Administrative Order NSL – 9110

**Chevron U.S.A., Inc. [OGRID 4323]
 SND 14 23 Federal Com P425 Well No. 425H
 API No. 30-015-53401**

Re: Chevron U.S.A. Inc.
Request for Administrative Approval of As-Drilled Unorthodox Well Location

SND 14 23 Federal Com P425 425H well
 W/2 Sections 14 and 23, Township 24 South, Range 31 East
 Eddy County, New Mexico
 Cotton Draw, Bone Spring [Pool 13367]
 API No. 30-015-53401

C-102

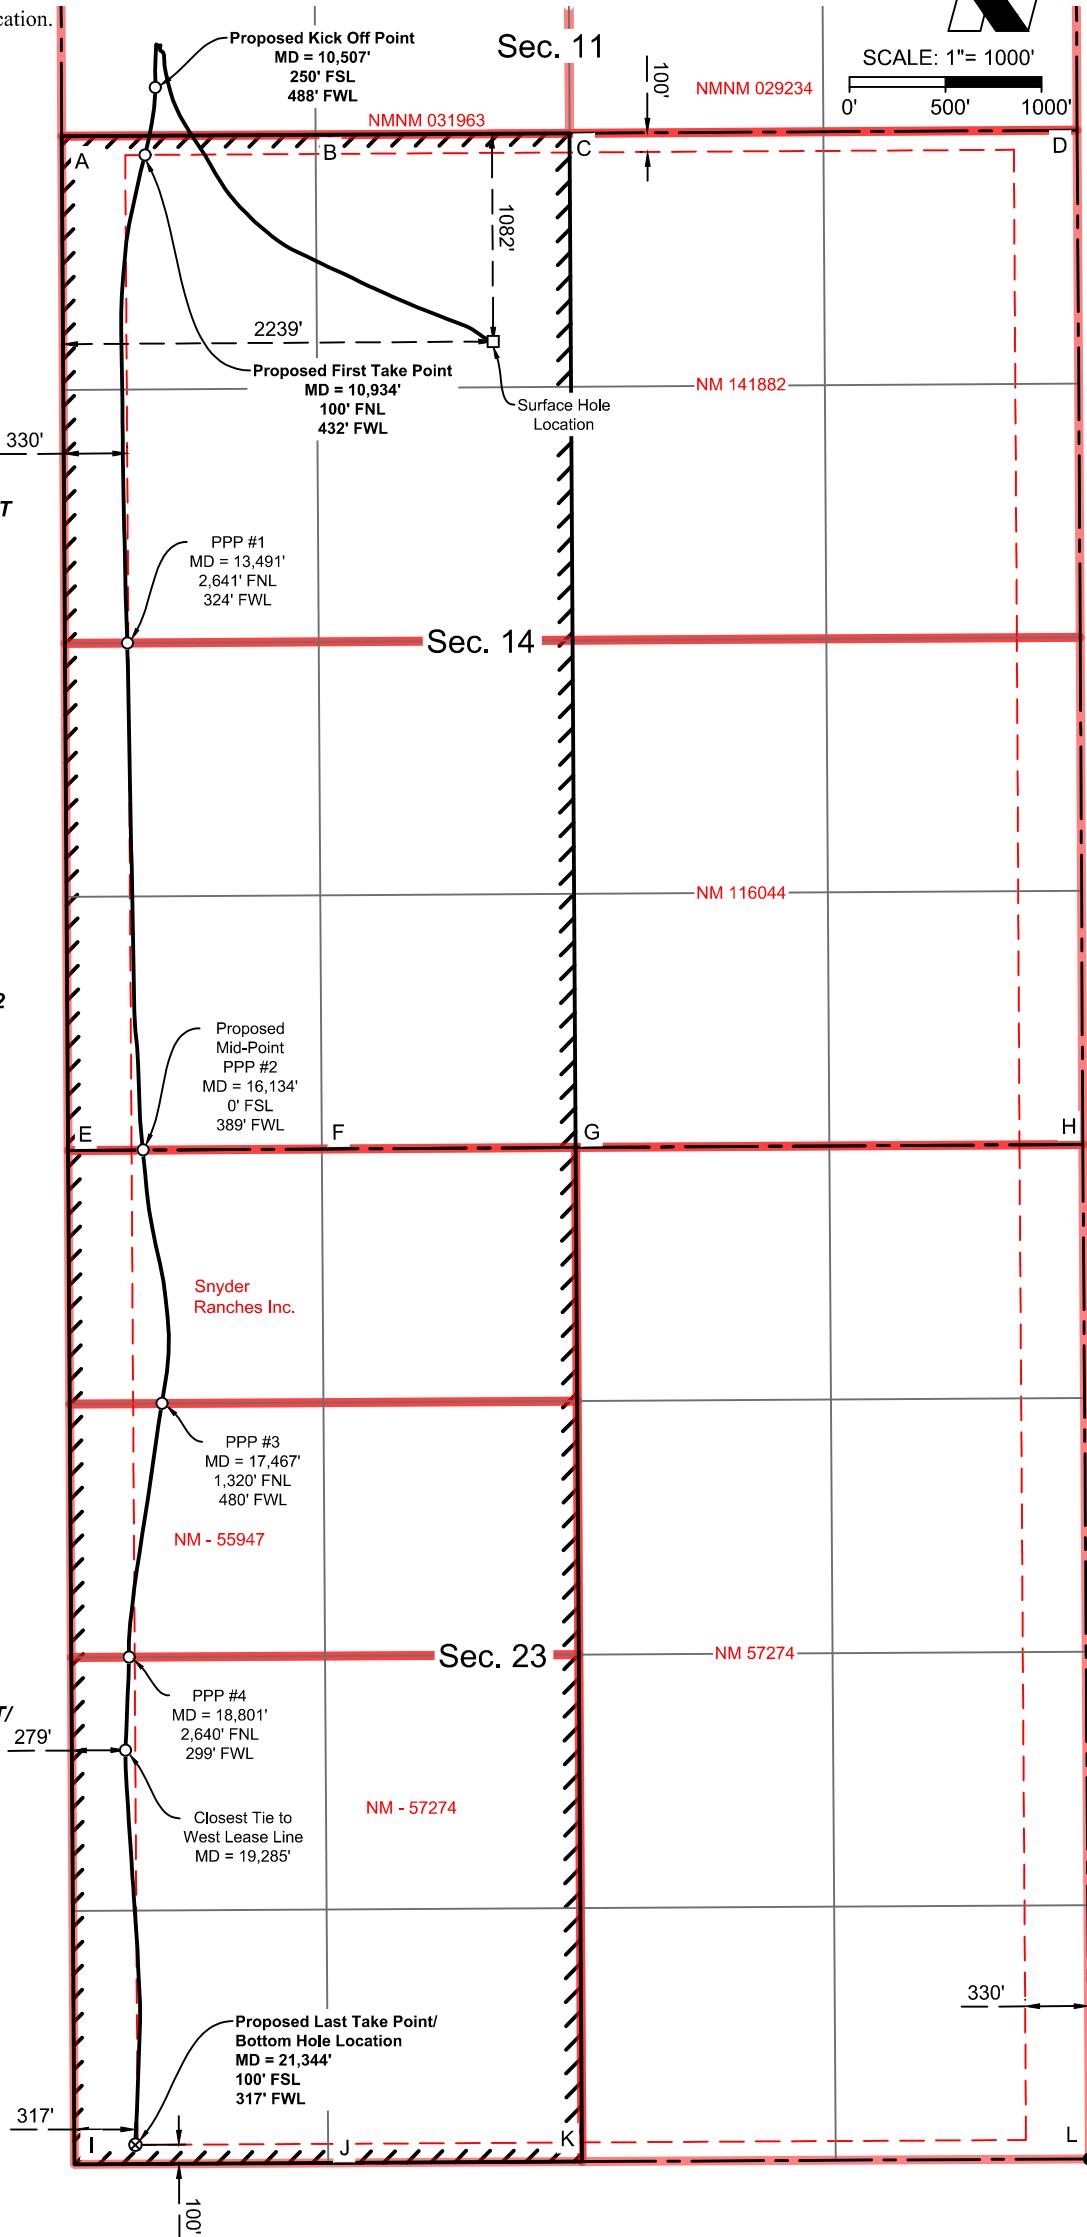
A limited portion of the completed lateral is more than 50 feet (instead located at 51 feet) from the previously approved projected location and closer to the outer boundary of the horizontal spacing unit than allowed¹; therefore, Chevron is seeking approval for the unorthodox portion of the as-drilled well location that encroaches on XTO Permian Operating, LLC's Poker Lake Unit (federal).

Exhibit A is a Form C-102 showing the as-drilled SND 14 23 Federal Com P425 425H well encroaches on XTO's Poker Lake Unit (federal). Also, included is the Form C-102 for the SND 14 23 Federal COM 001 P26 226H, the defining well for the spacing unit.

SND 14 23 FED COM 425H

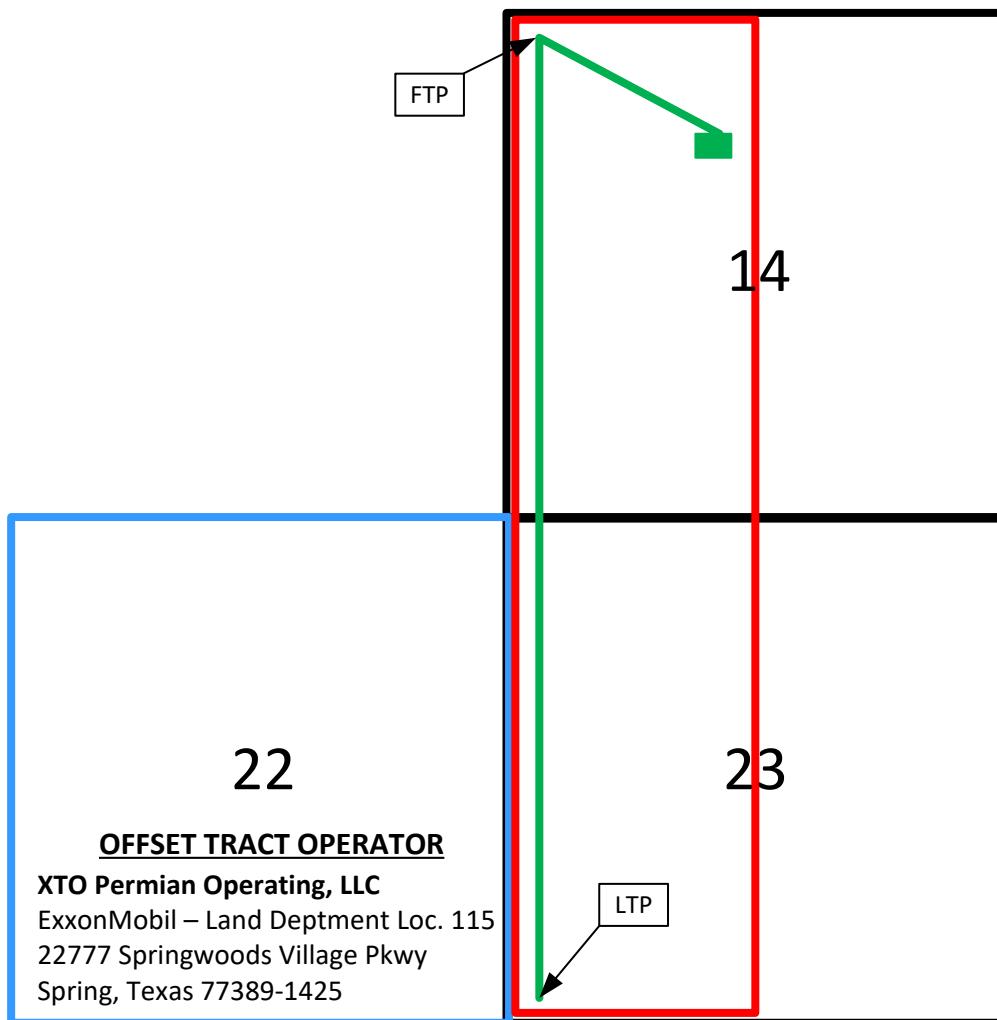
Exhibit B is a plat for Sections 14 and 23, that shows the SND 14 23 Federal Com P425 425H well in relation to the adjoining Poker Lake Unit (federal) to the west. Exhibit B also includes an ownership list for the Poker Lake Unit, showing that it is operated by XTO Permian Operating, LLC ("XTO"). In addition, the exhibit identifies the Bureau of Land Management ("BLM") and the State Land Office ("SLO") as affected parties since the Poker Lake Unit includes both federal and state leases. Accordingly, the "affected persons"² are listed in the table below.
